<b>ASHLAND PLANNING DEPARTMENT</b>	<b>SITE:</b>	Mountain Meadows Drive
<b>PRE-APPLICATION CONFERENCE</b>	<b>APPLICANT:</b>	Rogue
<b>COMMENT SHEET</b>	<b>REQUEST:</b>	Outline/Final Plan for 8 units, Site Review, Exception to Street Standards, Boundary Line Adjustment

September 9, 2020

Prototypical Section: Residential Neighborhood Street, Parallel Parking Both Sides

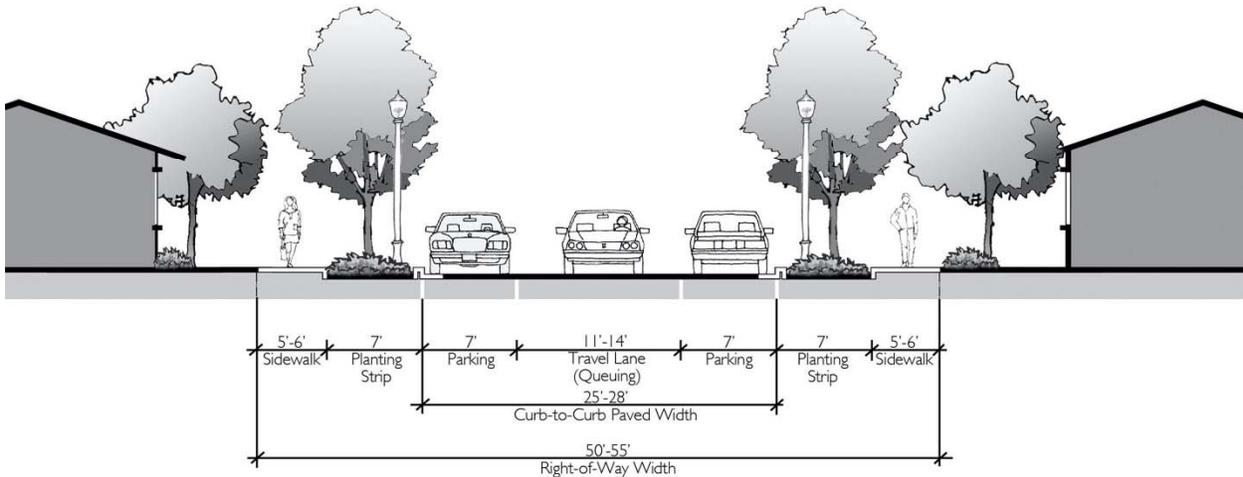
Streets in Ashland’s Transportation System Plan (TSP). The city standard improvement for a neighborhood street is 47-57 feet of right of way with 22-28 feet of pavement including 11-15 feet for travel lanes, seven to 14 feet for parallel parking, six-inch curbs on both sides, five-to-eight foot park row planting strips, and five-to-six foot sidewalks as described in AMC 18.4.6.040.G.4.a and generally illustrated in the proto-typical cross-section below:

As noted in the submittals, the right-of-way width shown is less than the minimum required for the street type and the head-in parking and street tree configuration are not to city street standards and would require Exceptions to the Street Design Standards. Placing required improvements outside of the existing right-of-way would require either dedication of right-of-way or easements, and would need to be supported by the Public Works/Engineering Department.
